Swedish Radiation Safety Authority

SSM's external experts' reviews of
SKB's safety assessment SR-PSU –
hydrogeological and chemical aspects
Initial review phase

SSM's external experts' reviews of
SKB's safety assessment SR-PSU –
hydrogeological and chemical aspects
Initial review phase

Review of hydrogeological site-descriptive model SDM- PSU – 1

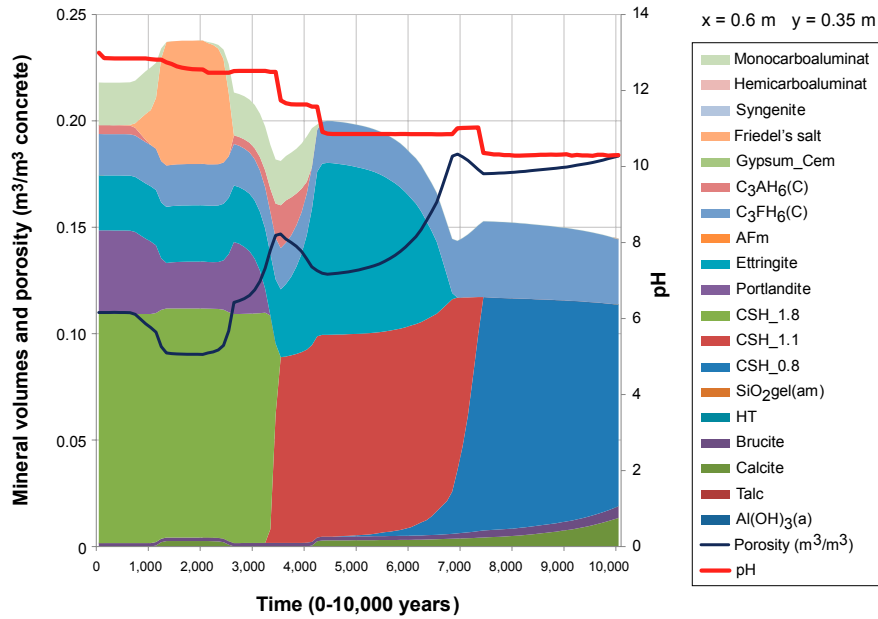
Somewhat unusually, in Höglund's model results for the interaction of the various concrete barriers with saline groundwater, this reaction is not accompanied by an increase in pH, e.g. Figure 5 (below).

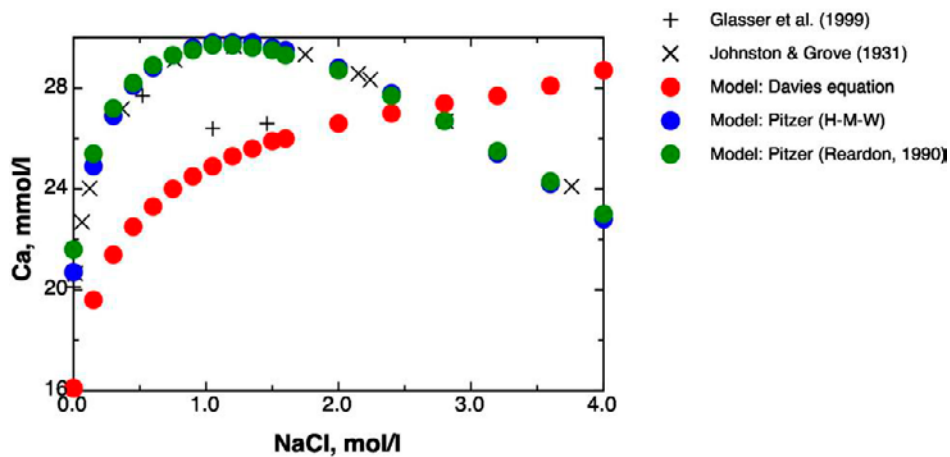
Another issue which is not mentioned by Höglund (Höglund, 2013) is that portlandite solubility is dependent upon salinity (see Figure 6). As stated above, the composition of groundwater selected by Höglund to represent saline conditions at SFR contains 5000 mg/L Cl⁻ (~ 0.14 NaCl mol/L) and would thus only slightly increase portlandite solubility according to data in Figure 6. Any underestimation of groundwater salinity would thus underestimate portlandite solubility however.

Figure 7 Schematic representation of zones of cement alteration in the experimental system of Kutchko et al. (2007) (from Wilson et al., 2011).

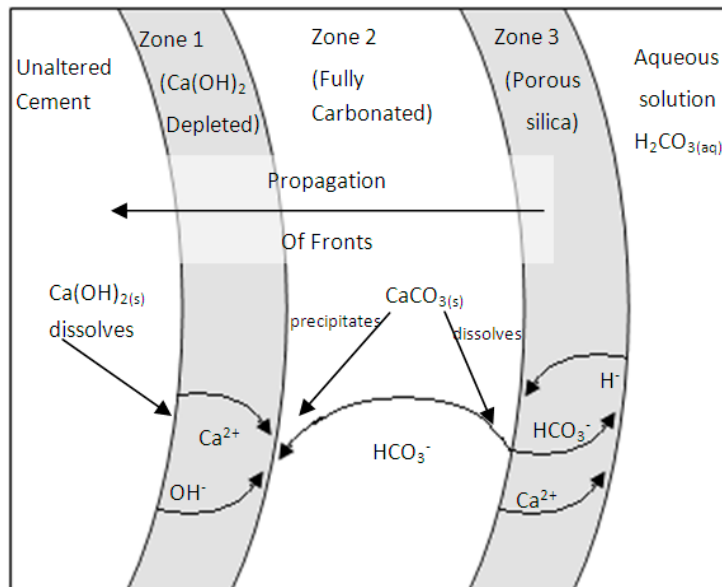
Natural analogues of cement and concrete degradation are discussed by Höglund in Section 4.1.4, but there is no mention of pertinent information from the oil industry. Cement carbonation, especially in saline solutions, is of considerable interest to the burgeoning CO_2 sequestration industry, where cement well seals are a key link in the performance of CO_2 storage systems (e.g. Wilson et al., 2011). There are numerous studies in this field, but as an example, Kutchko et al. (Kutchko et al., 2007) have described the degradation of ‘Class H’ cements under geological storage conditions, highlighting the occurrence of alteration zones. They report that in contact with *supercritical* CO_2 , cement is converted to calcite ($CaCO_3$) at a single reaction front. In CO_2 -saturated fluids, they identified three reaction zones (Figure 7) that form as a

result of the following processes: portlandite ($\text{Ca}(\text{OH})_2$) dissolution; calcite precipitation; calcite dissolution; and leaching of C-S-H gel to form amorphous silica ($\text{SiO}_{2(\text{am})}$). The depth of alteration was found to vary as a function of cement curing conditions, with reported values ranging from 0.59 to 0.22 mm. Further analysis of these systems may be rewarding regarding the understanding of concrete degradation at SFR.
